## STAFF REPORT COMMUNITY DEVELOPMENT DEPARTMENT

SUBJECT: H-2020-0008  
Fairbourne No.3

Final plat consisting of 65 buildable lots and 8 common lots on 23.26 acres of land in the R-8 zoning district.

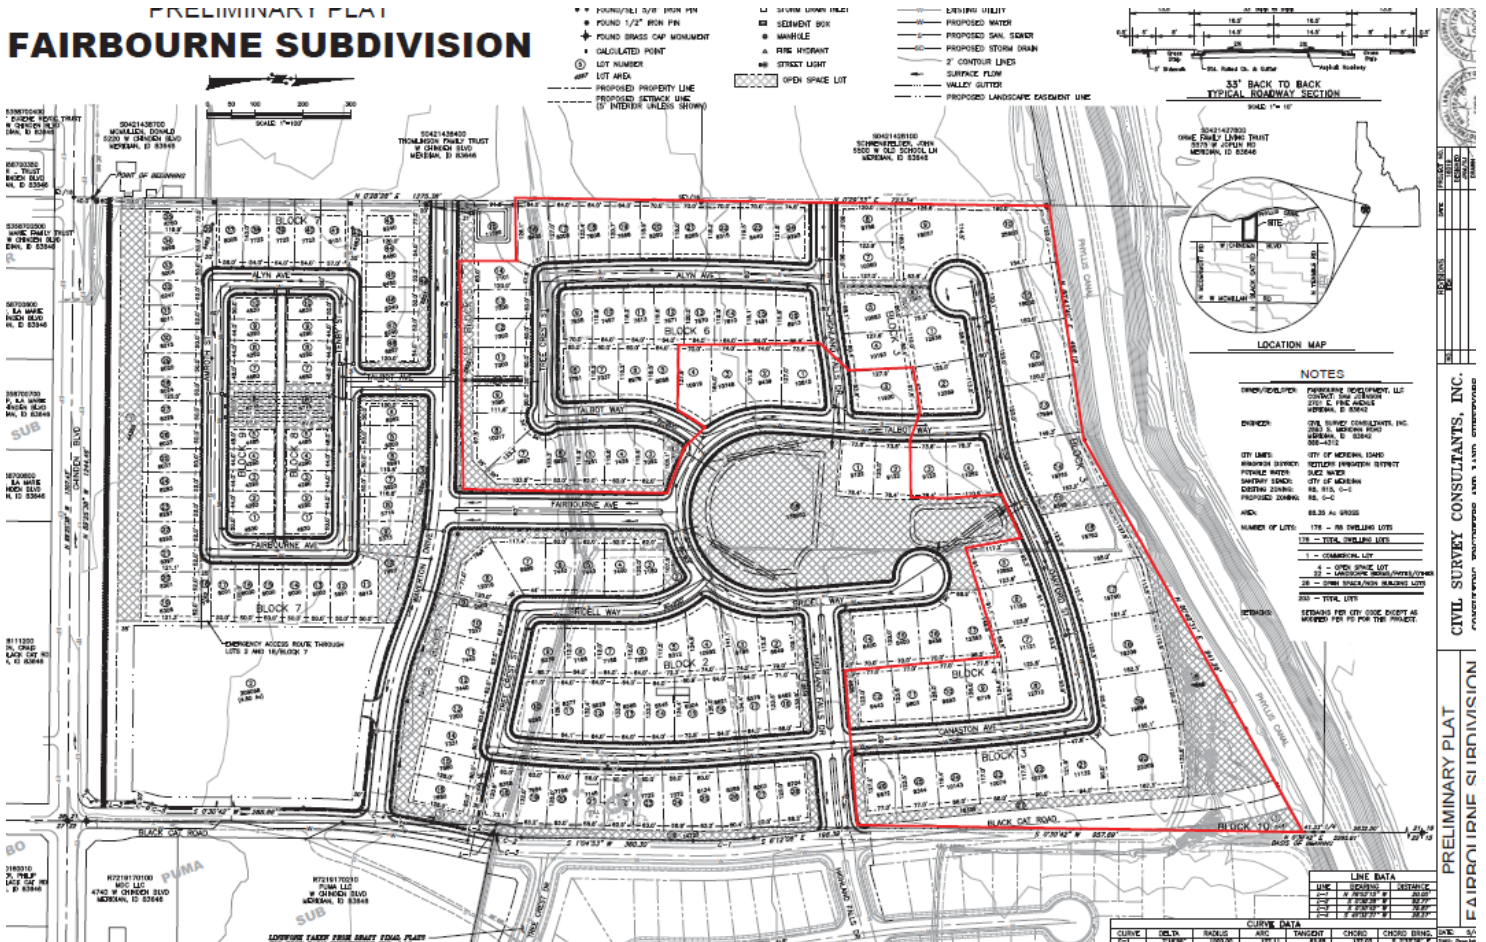
In order for the proposed final plat to be deemed in substantial compliance with the approved preliminary plat as set forth in UDC 11-6B-3C.2, the number of buildable lots cannot increase and the amount of common area cannot decrease. There is an additional micro-path and common lot between Lots 19 and 21 of Block 5 that was not included on the preliminary plat which has increased the amount of common open space. Otherwise, there is no change to the number of buildable lots or

common open space. Therefore, Staff deems the proposed final plat to be in substantial compliance with the approved preliminary plat as required.

**PHASE THREE- LANDSCAPE PLAN- AREA THREE**

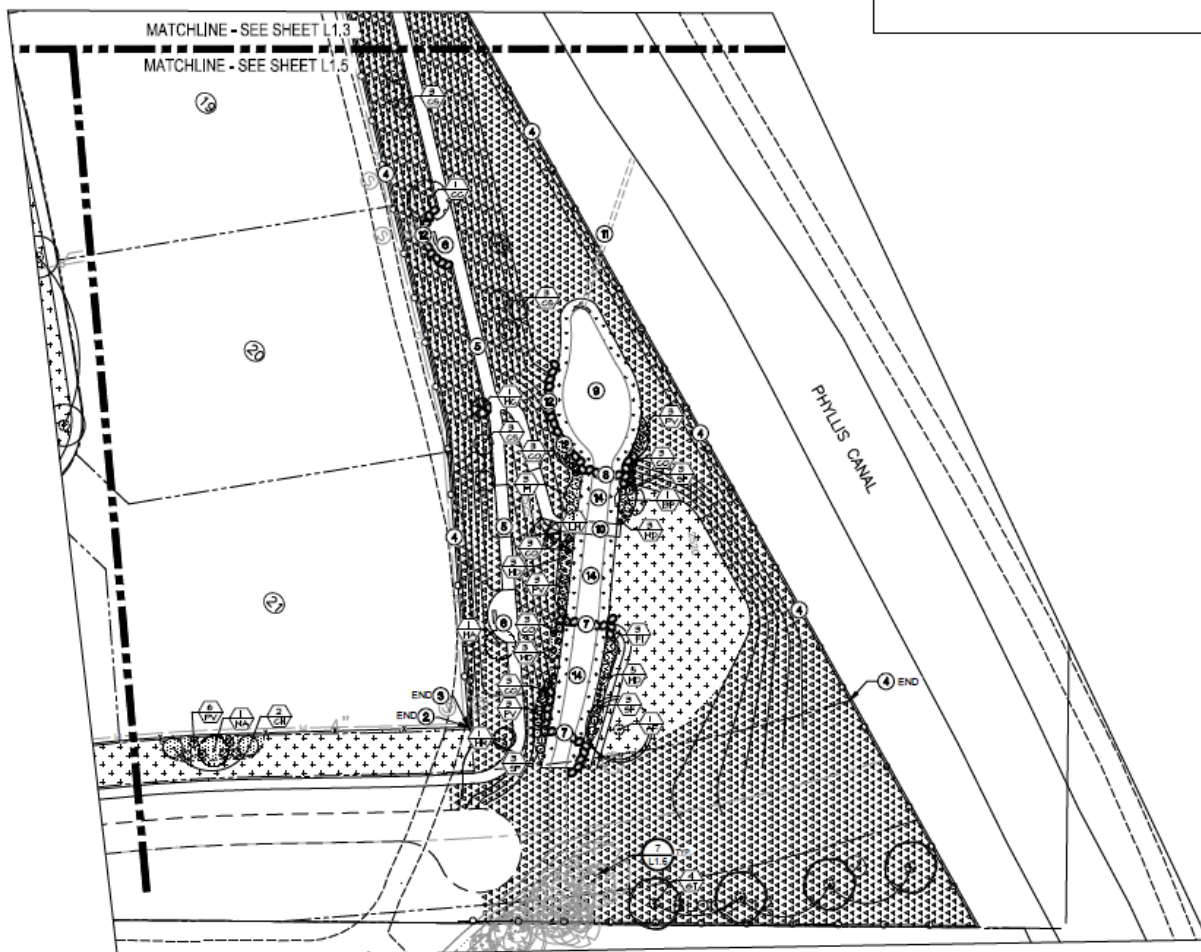
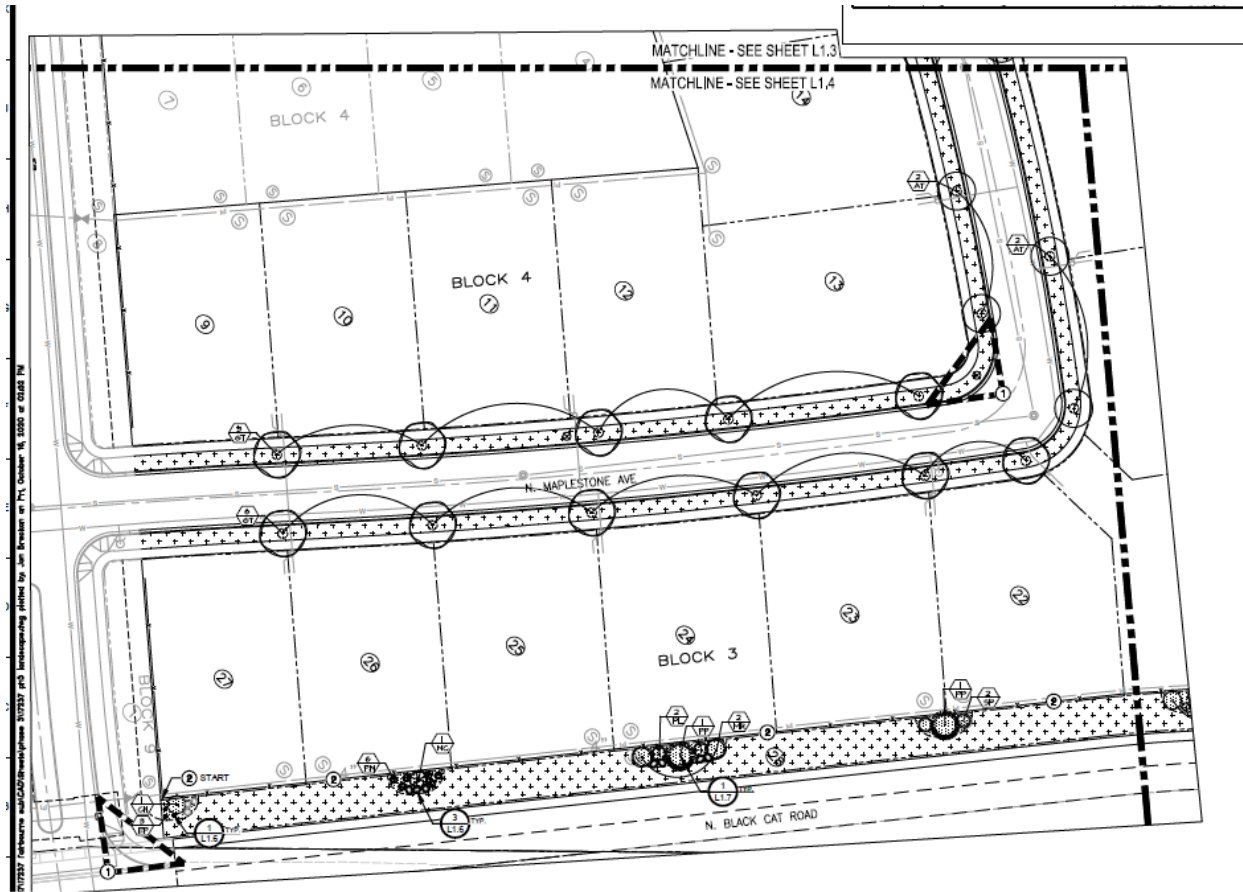
5. The landscape plan prepared by Breckon Landscaping, dated 10/09/2020, is approved with the following condition:
  - a) Prior to submittal for the City Engineer's signature, the landscape plan will be revised to include details of the pond and waterfall features in Lot 29, Block 12.
